Technical Note

Project: Former Masonic Hall and Old Telephone Exchange Site, Elmsleigh Road, Staines

Subject: Response to Highway Comments and SCC RSA

Client:	Inland Homes Ltd	Version:	A
Project No:	04550	Author:	LS
Date:	15/02/2021	Approved:	MF

Appendix A Pedestrian Visibility Plan

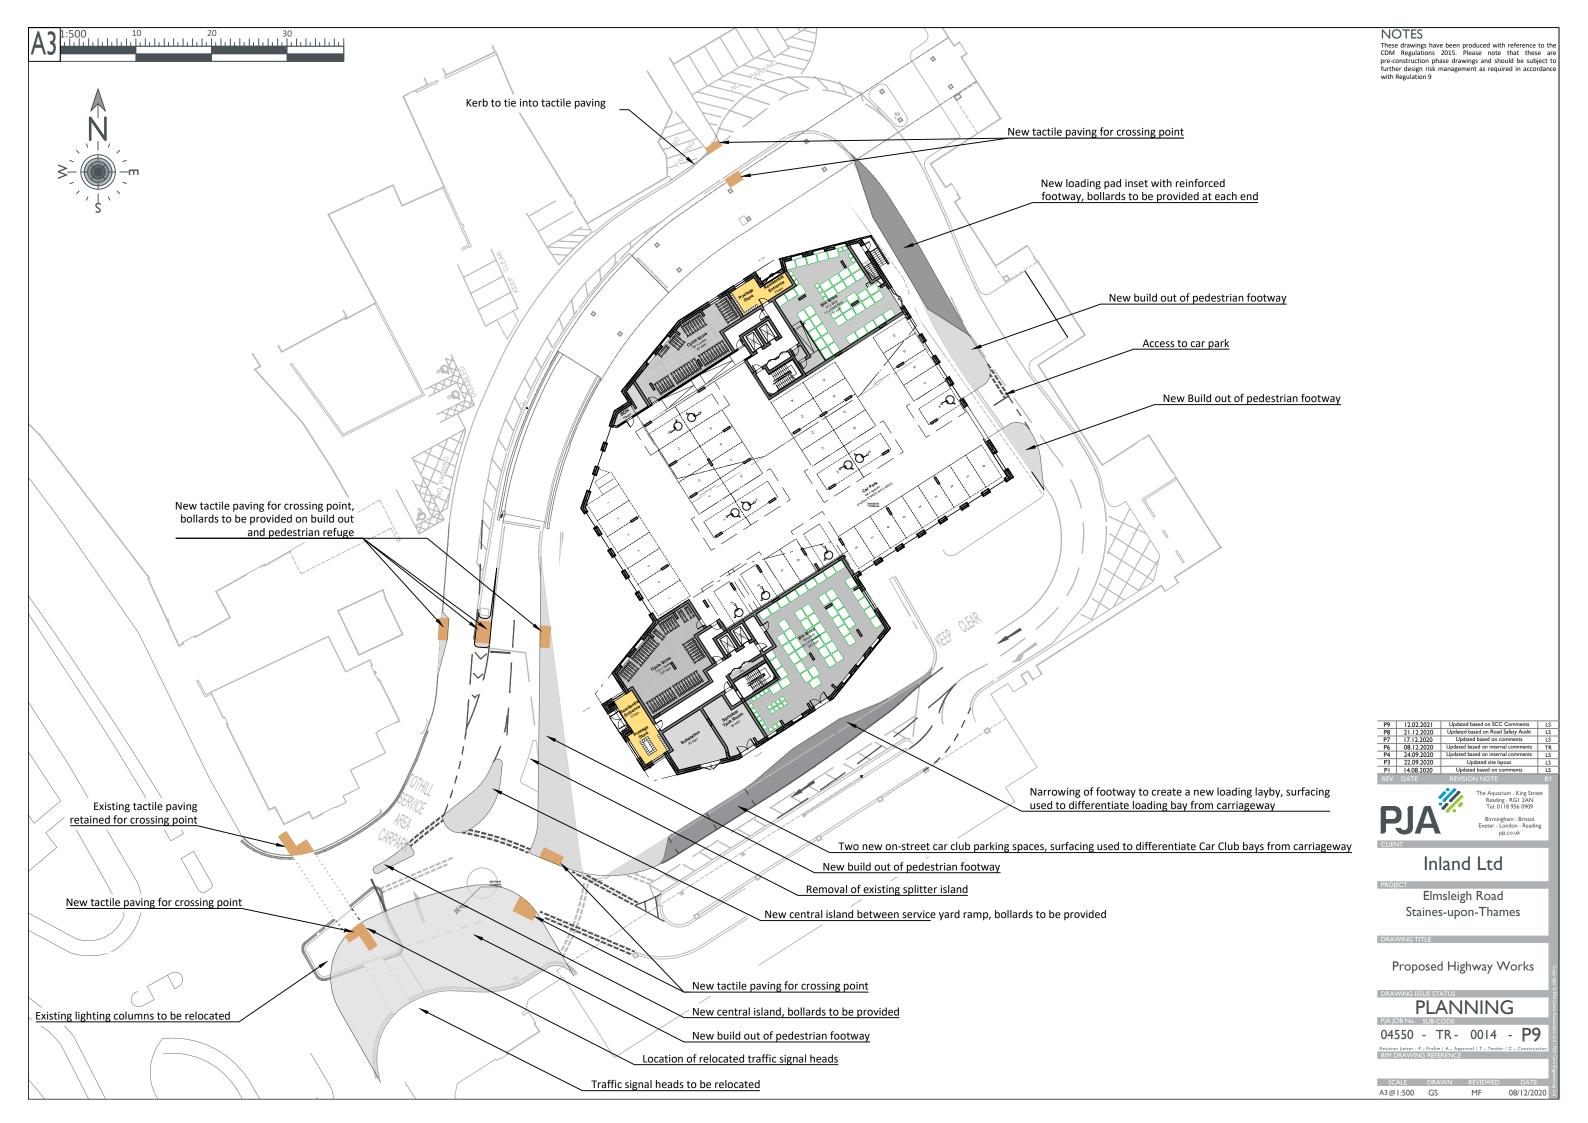
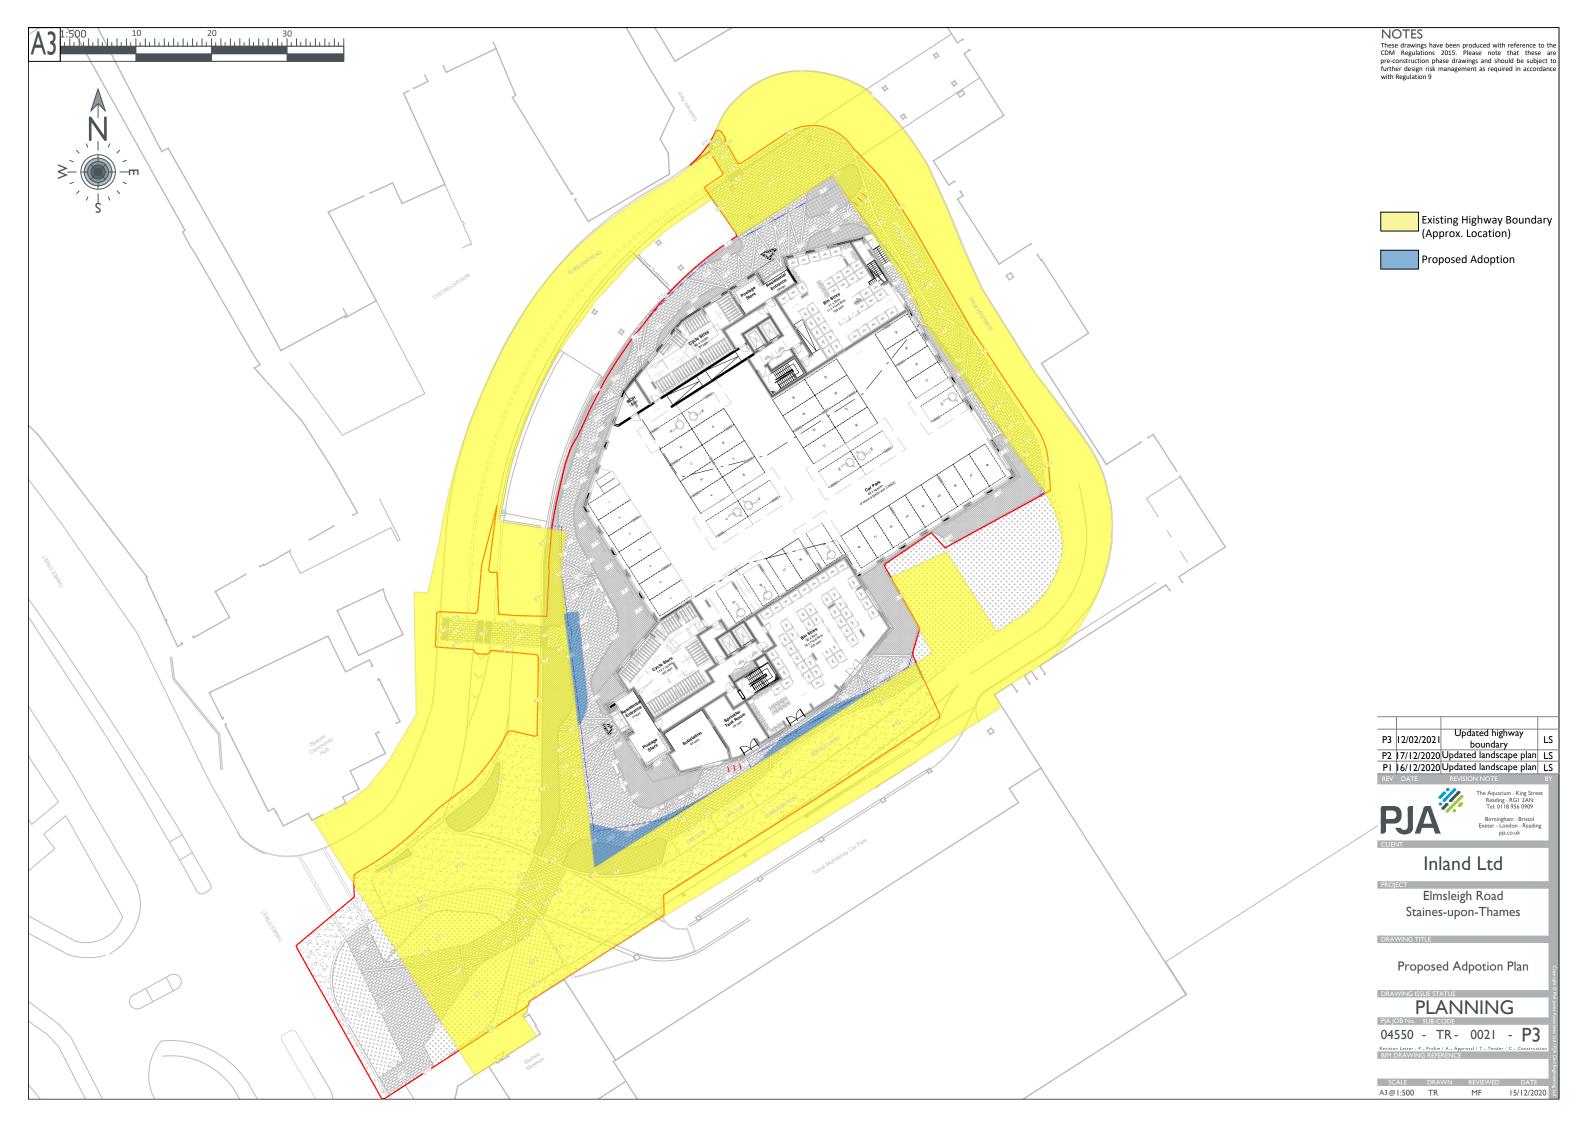
SCC Comment / RSA Problem	RSA Recommendation	Design Organisation Response	Overseeing Organisation Response	Agreed RSA Action
The splay drawings provided appear to show pedestrian visibility measured to the kerbline. In practice, pedestrians are likely to stand approximately 0.5m back from the edge of carriageway when they check for oncoming traffic. Please could these drawings be updated to show a set back of 0.5m?	N/A	An updated pedestrian visibilities plan has been prepared, with the visibility measured to 0.5m back from the edge of the kerb, included as Appendix A . This shows that the required visibilities can be achieved with this offset (details of the rationale behind the required visibilities is provided in the December 2020 Technical Note).		
A1.1. Summary: restricted visibility for and of pedestrians at uncontrolled crossing. Visibility for and of pedestrians using the proposed uncontrolled crossing on the west side of Elmsleigh Road is restricted to the south, despite the proposed kerb buildout, by the building line and fencing of the adjacent property. Pedestrians attempting to cross the carriageway via the uncontrolled crossing to the central refuge, are at risk of conflict with northbound drivers proceeding within Elmsleigh Road. This is of particular concern for the visually impaired, the mobility impaired and pedestrians with pushchairs.	Provide visibility for and of pedestrians in accordance with current advice at the proposed uncontrolled crossing. Increase the width of the western footway and reduce the running lane width at the proposed uncontrolled crossing to improve visibility for and of pedestrians.	The pedestrian visibilities plan included as Appendix A demonstrates that the building line and fencing do not encroach on the visibility splay for pedestrians using the crossing on the west side of Elmsleigh Road. This is measured from the likely position of a pedestrian to the likely position of a driver. There is therefore no need for the western footway width to be increased.

Appendix B Highway Works and Adoption Plans

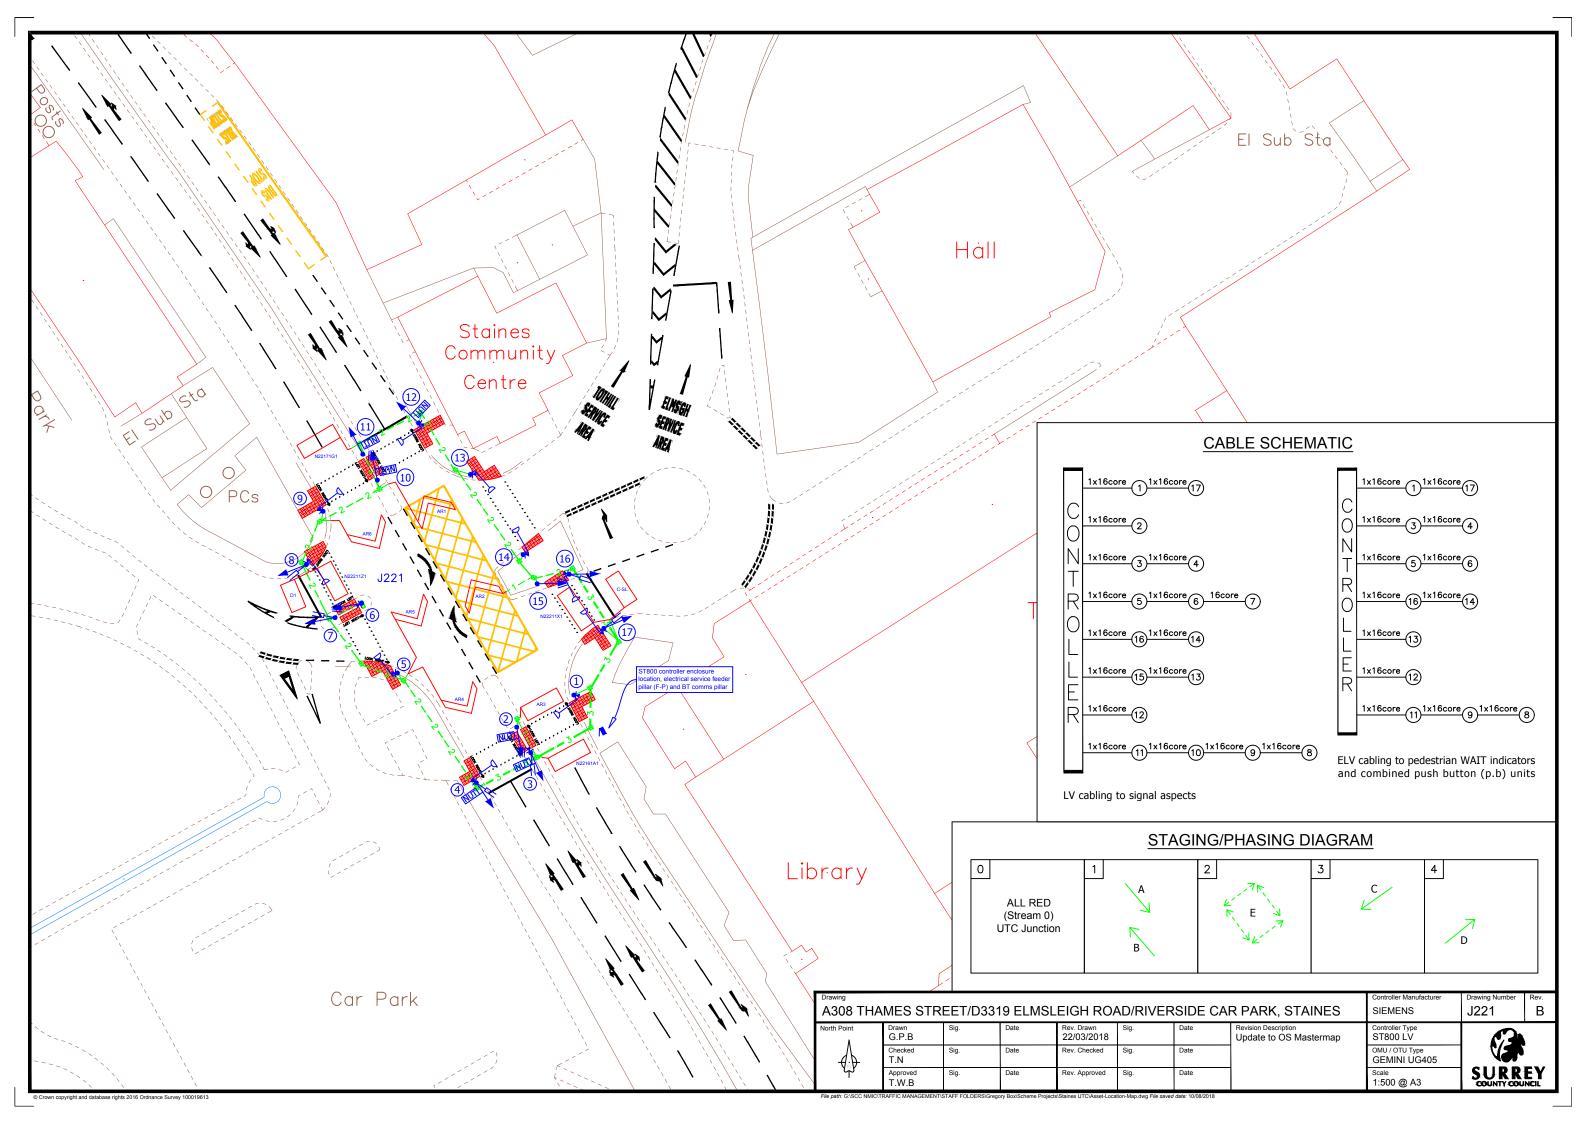
A1.2. Summary: risk of pedestrian conflict at contrasting 'courtesy crossings'. Pedestrians may believe that the proposed 'courtesy crossings' which are proposed to have contrasting surfacing are controlled crossings, or that they have priority over approaching traffic. Pedestrians entering the carriageway expecting vehicles to stop / slow are at risk of conflict.	Omit the proposed contrasting coloured carriageway surfacing at each 'courtesy crossing, to provide a uncontrolled crossing with bituminous surfacing, as per the adjacent carriageway.	Contrasting surface is used as a means to make drivers more aware of the presence of the pedestrian crossings. The contrasting surfacing has been removed from the drawings at present (an updated highway works plan is included as Appendix B), and the suitability of this will be reviewed at detailed design stage.
